US DEPARTMENT OF ENERGY
HANFORD WASTE VITRIFICATION PLANT

DESIGN CHANGE NOTICE

DCN -0069

DCN TITLE
VIT. BLDG FIREWATER
PUMPHOUSE FWX & SWX
UTILITY STUBOUTS

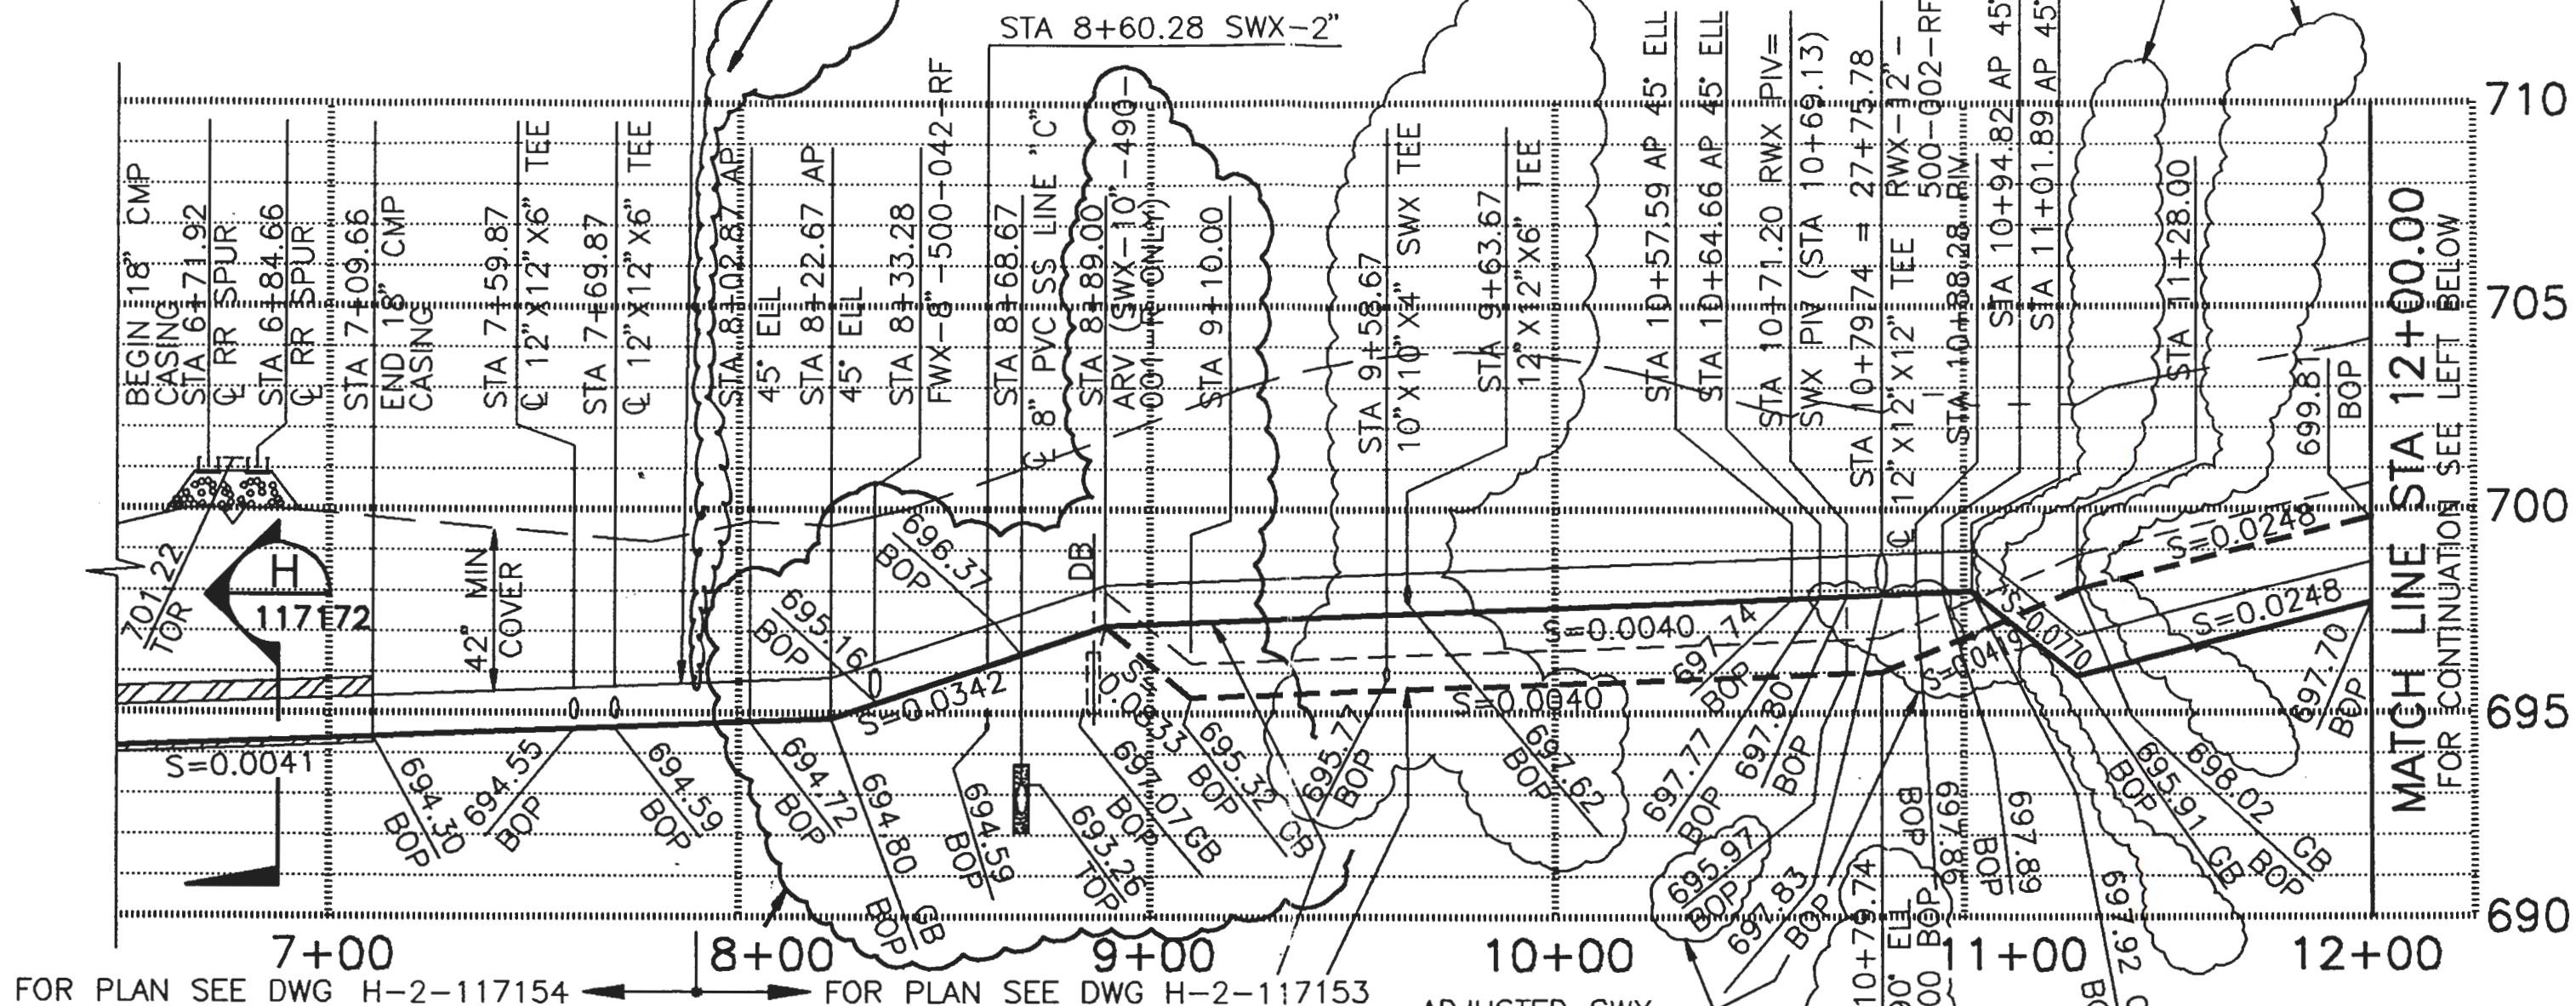
PLANT CONSTRUCTION ROAD CWB-430
RELOCATED UTILITY COORDINATES & ELEVATIONS FOR ITEMS A & B PER DCN 0069

ADDED FWX AND SWX STUBOUTS PER DCN 0069

UPDATED LOCATION OF VIT BLDG FIREWATER PUMPHOUSE AND TANKS PER DCN 0069

DELETED FWX AND SWX STUBOUTS PER DCN 0069

PER DCN-0069, REV 1

PER DCN-0069, REV 1

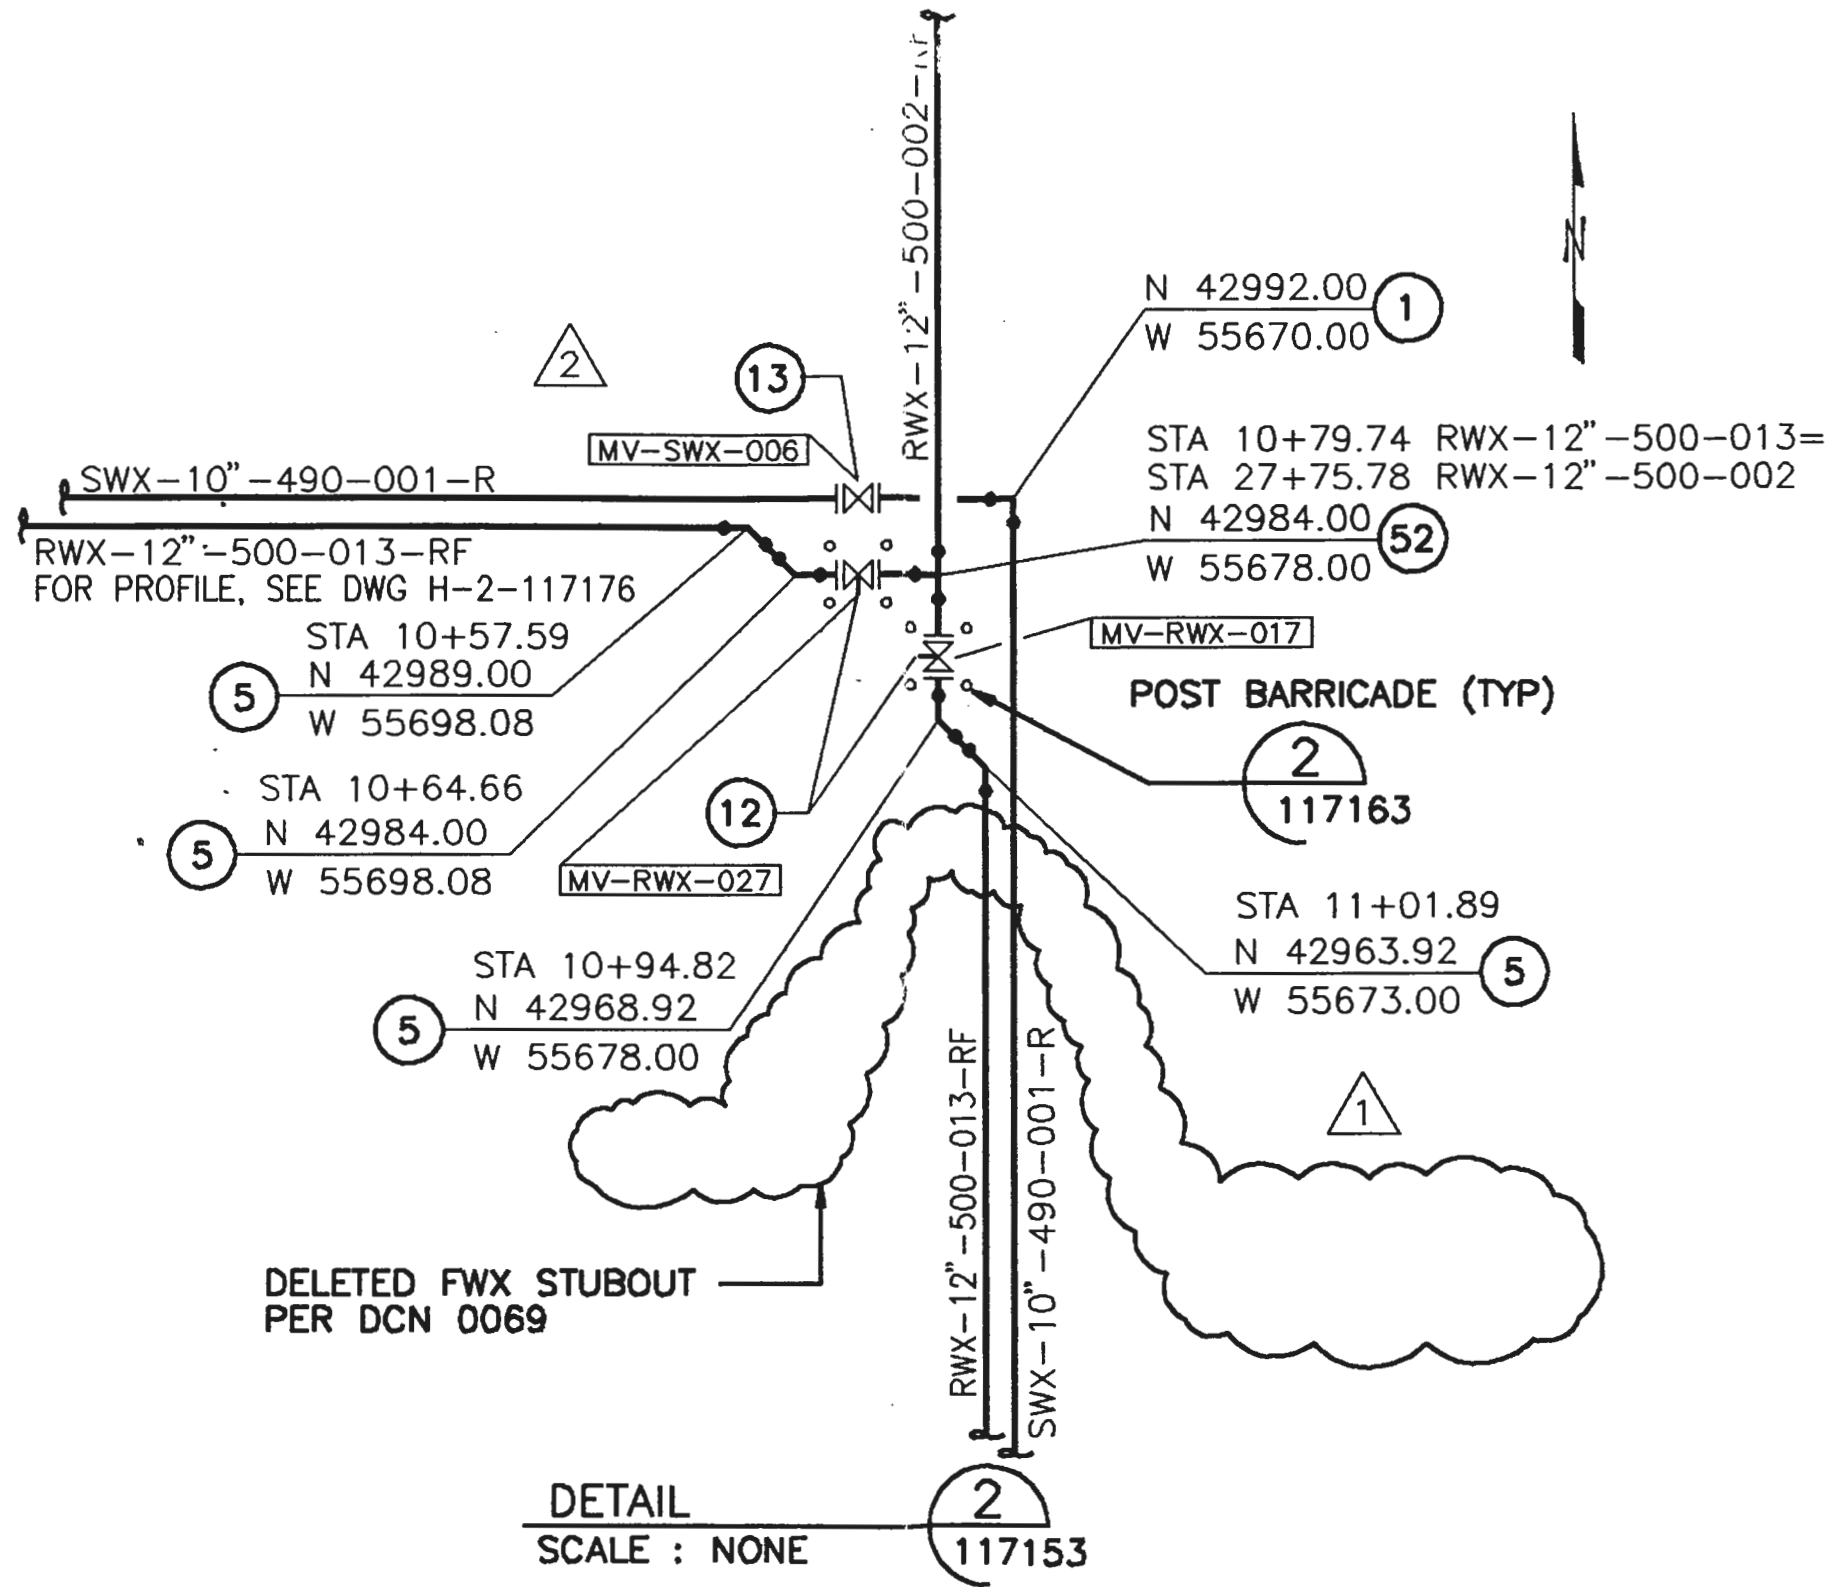
DELETED ARV AS REQUIRED PER DCN-155, REV 1 AT STA 7+96.87

ADDED FWX & SWX STUBOUTS PER DCN 0069

DELETED FWX & SWX STUBOUTS PER DCN 0069

REVISED VERTICAL ALIGNMENT AS SHOWN AND ADDED ARV AT STA 8+89.00 PER DCN-0069, REV 1

ADJUSTED SWX VERTICAL ALIGNMENT PER DCN 0069
